Detailed Site Plan Departure from Design Standards Alternative Compliance Flats at Glenridge Station

DSP-23008
DDS-24002
AC-24005

SUBJECT: Detailed Site Plan DSP-23008
Departure from Design Standards DDS-24002
Alternative Compliance AC-24005
Type 2 Tree Conservation Plan TCP2-001-2025
Flats at Glenridge Station

Figure 1: Site Plan

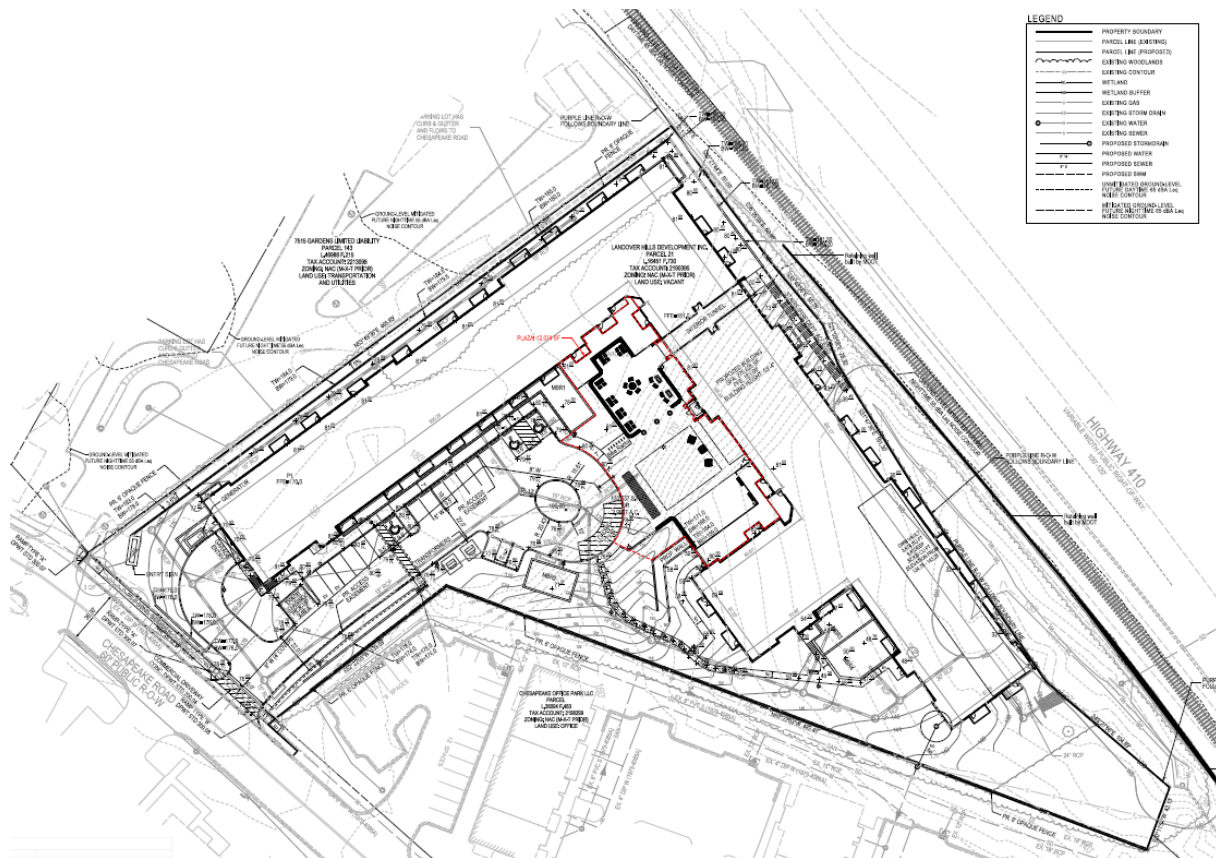
6. **Design Features:** The applicant proposes to construct one mixed-use building with 245 multifamily dwelling units and 1,380 square feet of office space. The proposed building will be designed with several green building techniques, including energy star appliances and windows, and high efficiency water heaters and mechanical systems. Micro-bioretenment areas are also integrated into landscape design, particularly around the surface parking area.

The proposed building is designed oriented toward Chesapeake Road, in which one vehicular access point is located. The L-shaped building sits at the back of the property and encloses a central plaza in front of it, which provides various seating options and other facilities. Walkways are provided to connect this plaza to the sidewalk within the Chesapeake Road frontage, for pedestrian connectivity. When vehicles enter the property, most of them will immediately turn left to enter the parking structure, which is located within the proposed building, under the residential dwelling units. Some vehicles may be parked on the surface parking spaces along the drive aisle, which leads to the central plaza.

Figure 5: Detailed Plan for Central Plaza

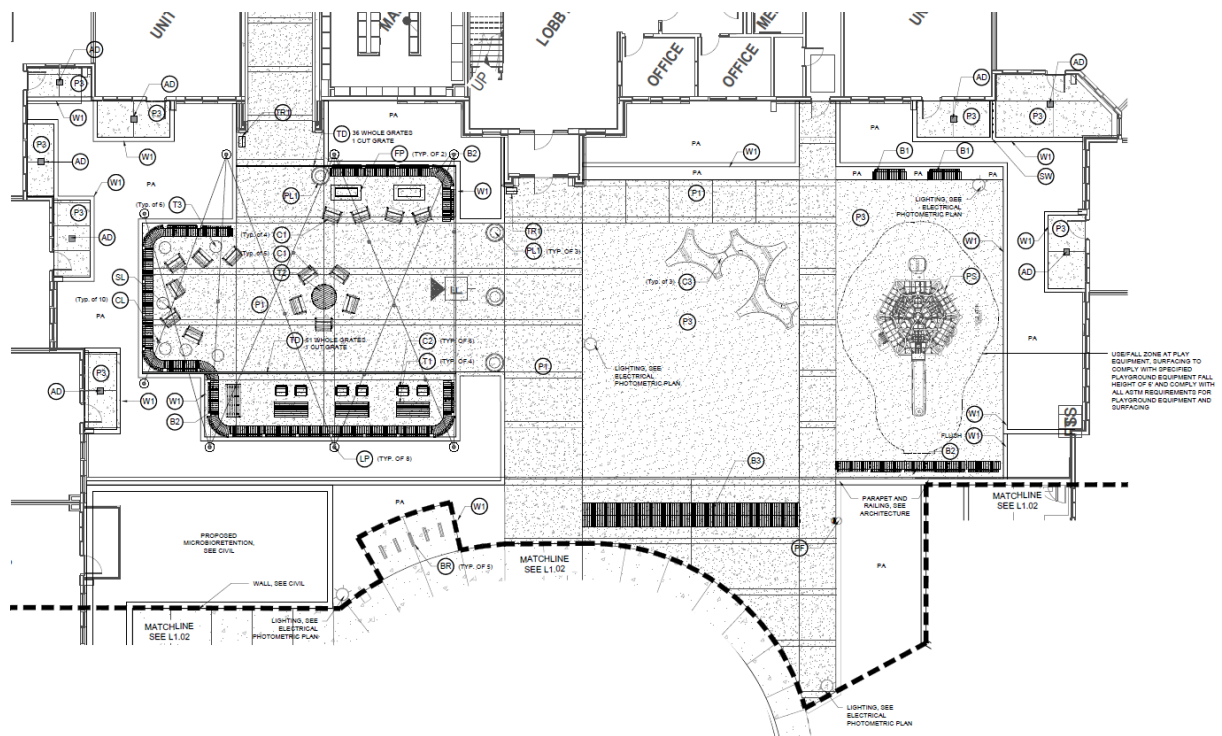
within the plaza. The surface of the plaza is designed with a variety of paving, such as scored concrete with/without integral colors, masonry, artificial turf for safety, and detectable warning pavers. Lighting is incorporated to provide for both safety and visual effect, especially during the evening. A public access easement will be expected to ensure its accessibility to the public, as shown on the submitted plan. With the provision of this plaza, this DSP receives an additional, approximately 0.74 FAR (or 96,592 square feet).

Utilizing the two optional methods as discussed above, the total FAR permitted for the subject DSP is approximately 2.14 (or 279,544 square feet). The total square footage of the development, proposed with this DSP, is 275,625 square feet (approximately 2.11 FAR), which is below the permitted FAR. The submitted site plan shows the boundary of the plaza for a public access easement, to ensure public access and use, but does not delineate the walkway area on the plan, to ensure the public can actually access the plaza. Conditions are included herein requiring the applicant to execute a public access easement or covenant at the time of final plat and delineate a public pedestrian easement for public access.

Figure 6: Relationship between Building, Purple Line and MD 410

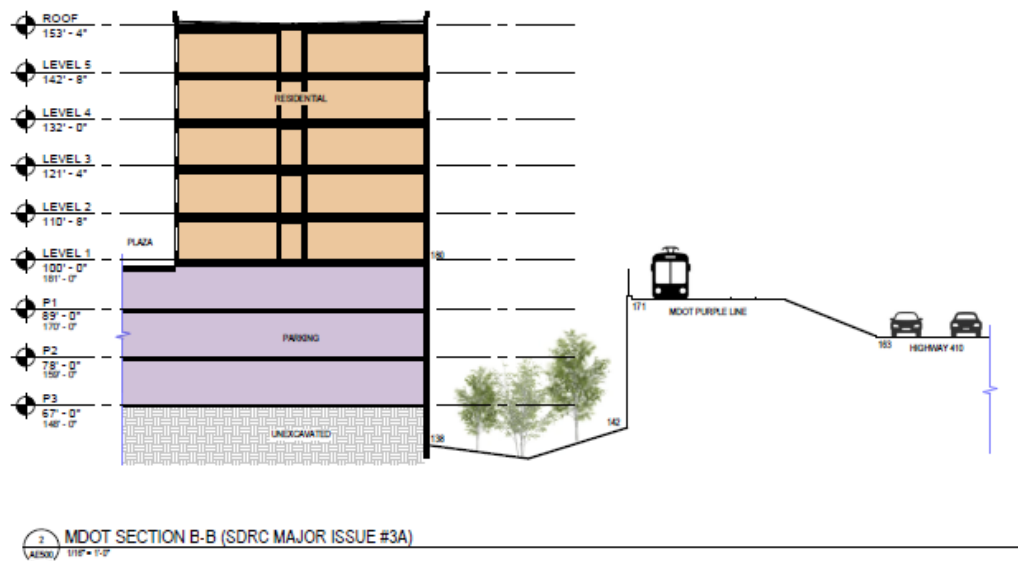
The required 50-foot-wide buffer, with plants, will likely be provided by the existing vegetation within the ROW of MD 410, which separates the proposed building from the Purple Line tracks. The subject DSP concentrates density in a mixed-use building on a property near a transit station. This approach will not overcrowd the land and, instead, leave some area for open space to bring light and air to the property. In particular, the applicant proposes open space in the form of a plaza in front of the building.

Given that the subject is in proximity to a Purple Line station, this subject DSP is for a compact transit-oriented development. Future residents will be likely to use the transportation system because the station is within a walkable distance. This will help lessen the danger and congestion of traffic on the streets. Without granting this departure, the proposed building will provide fewer dwelling units near a transit station.
